**ADDENDUM NO. 4**

The following attached changes are incorporated into requirements for the Project No. 33-SBC-1008 Contract Documents by this Addendum:

KITTITAS RECLAMATION DISTRICT  
 ELLENSBURG, WASHINGTON  
 SOUTH BRANCH CANAL IMPROVEMENTS  
 ROBINSON SIPHON (MP 10.0) TO MANASTASH CHUTE (MP 13.9)  
**SOUTH BRANCH CANAL PIPELINE CONVERSION**  
 33-SBC-1008; 2024-25 REACHES  
 (MILEPOST 12.4 TO MILEPOST 13.6)

**CONTROL STRUCTURE 12.8 & TURNOUT 13.0**  
TURNOUT PLAN & SECTION VIEWS

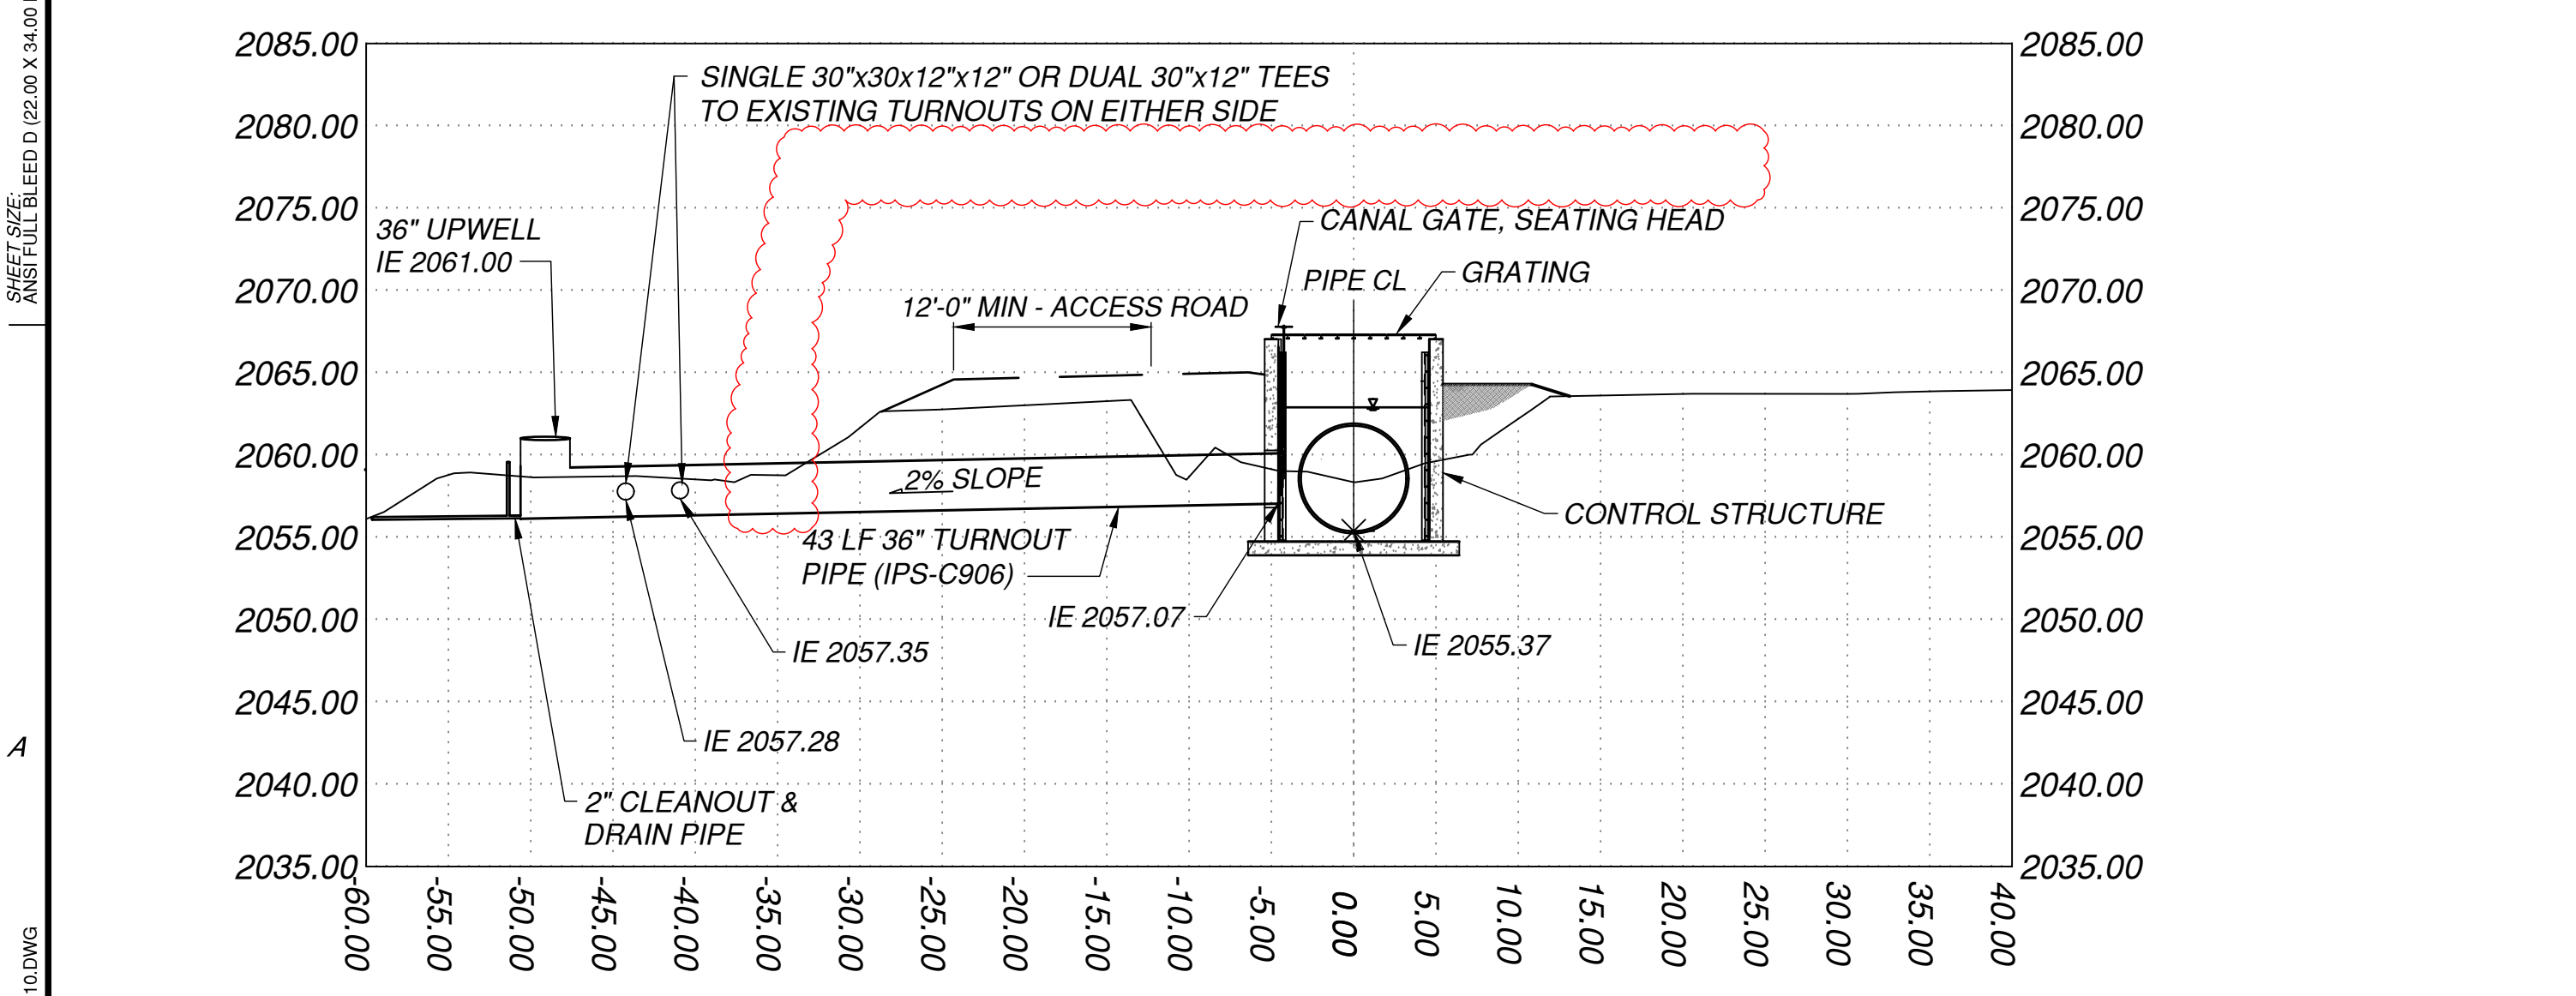
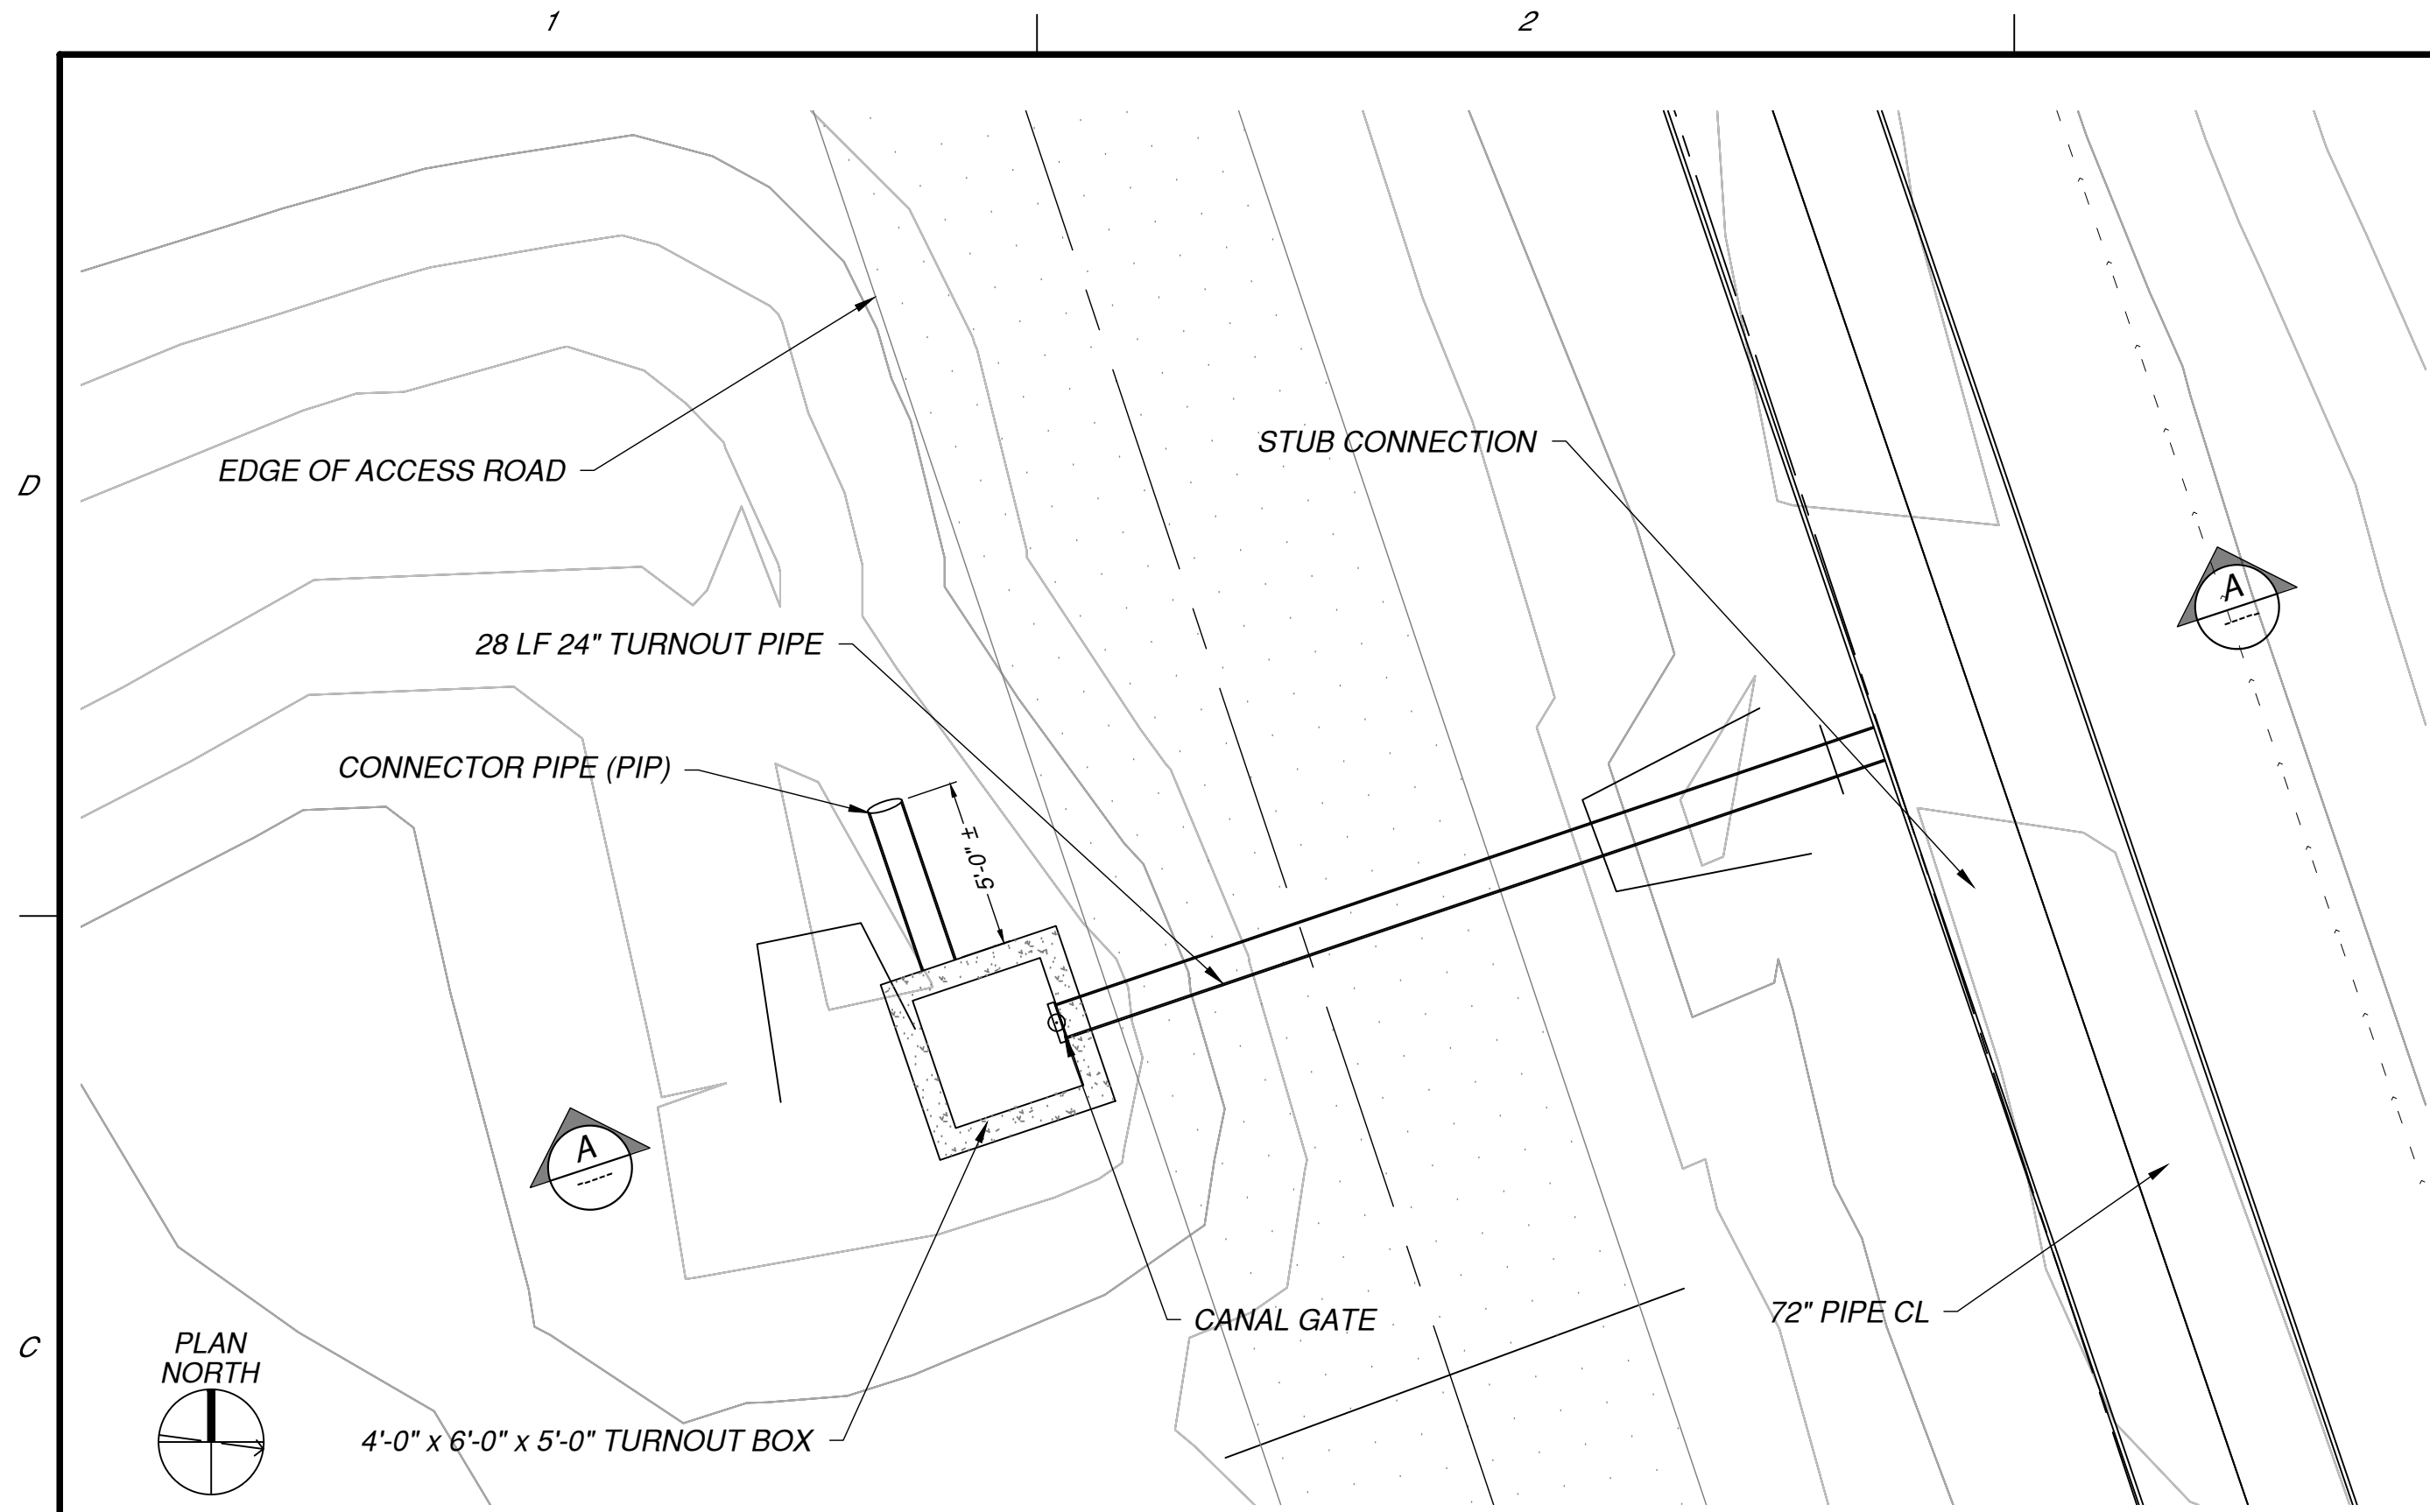
Q1. *Is there any electric work needed for the two (2) flowmeters at the control structures?*

- Added Revision 1 for removal of the flow meter from SB12.8 shown in Section 156+00.39.

REV. NO.	DESCRIPTION	DATE
1	REMOVED FLOW METER FROM XSBI2.8 SECT. 156+00	10-30-2024
0	ISSUED FOR BIDDING	10-04-2024

No, see attached revised drawings C314 and C316 for removal of the flow meters associated with the SB12.8 lateral and SB13.6 screening structure. The intent of the original callouts was for the meters to be mechanical registers that do not require electrical power. However, the District has decided that existing flow monitoring further downstream will suffice and the new meters can be omitted from the bid.
